Addendum Number Two

To the Drawings and Specifications for:
24/7 Travel Store, Goodland, Kansas

Issued: Thursday, September 18, 2020

HANNEY & ASSOCIATES ARCHITECTS

1.15 Concrete Salt Guard

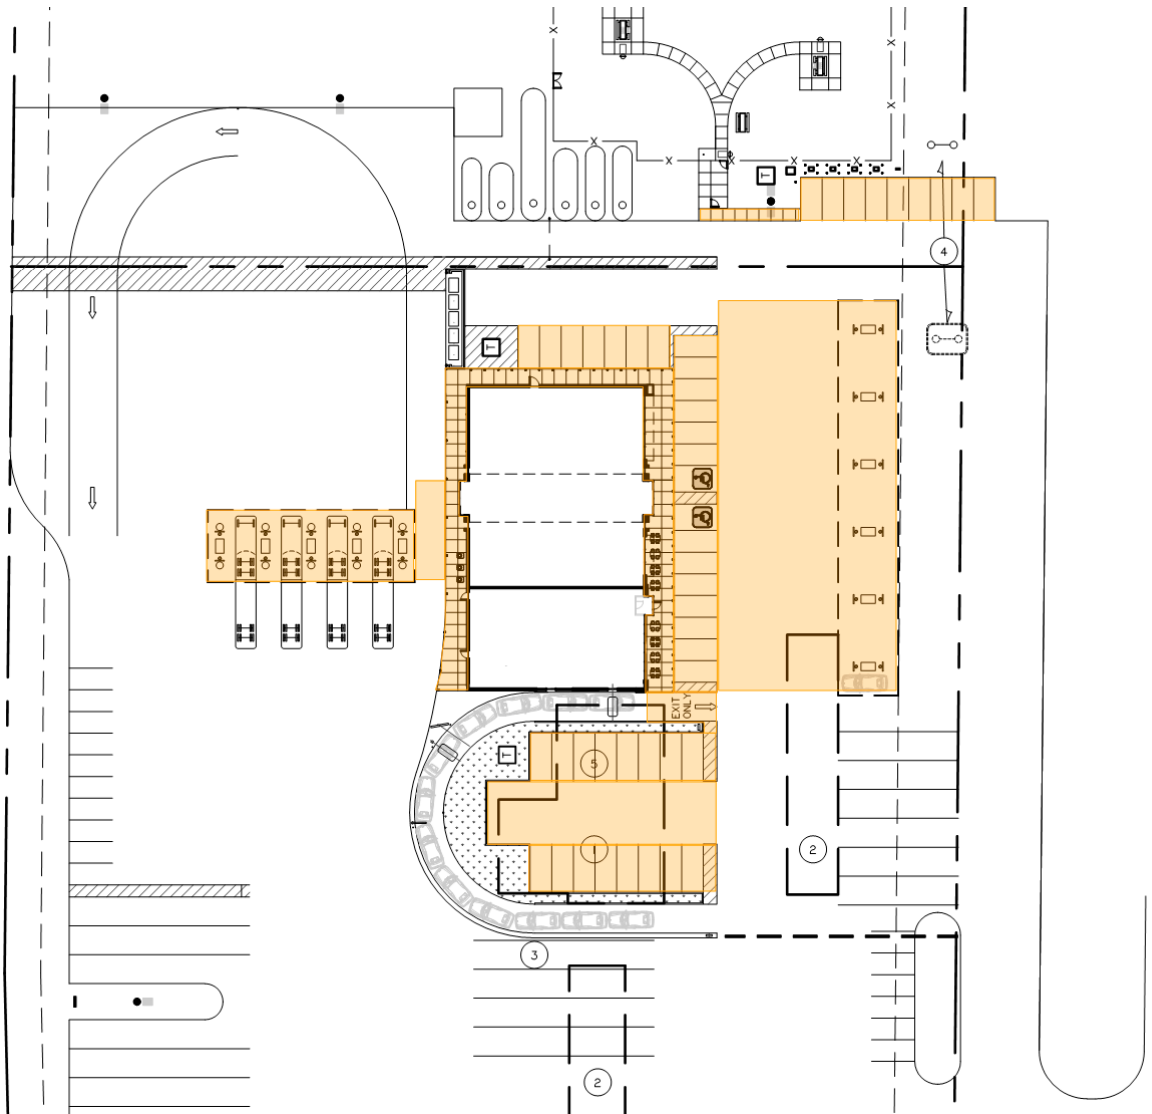
Areas of the concrete shall be protected with Salt Guard as manufactured by Carter-Waters. This coating is called out on Sheet AS1.1, and in the specifications Section 03300-Concrete. The scope of the Salt Guard installation shall be as shown in orange on the sketch below:

- 2.3 Section 03300 – Concrete
 - Paragraph 1.7 Protection and Curing, item
 - a. Paragraph 19 – Joints in Concrete, Item 19.7 Salt Guard.
This product is made by Carter-Waters, and is used by 24-7 Travel Stores at all their facilities. The application of the Salt Guard shall be per the manufacturer’s recommendation. Refer to Item 1.14 in this Addendum for an illustration of the areas to receive the treatment.
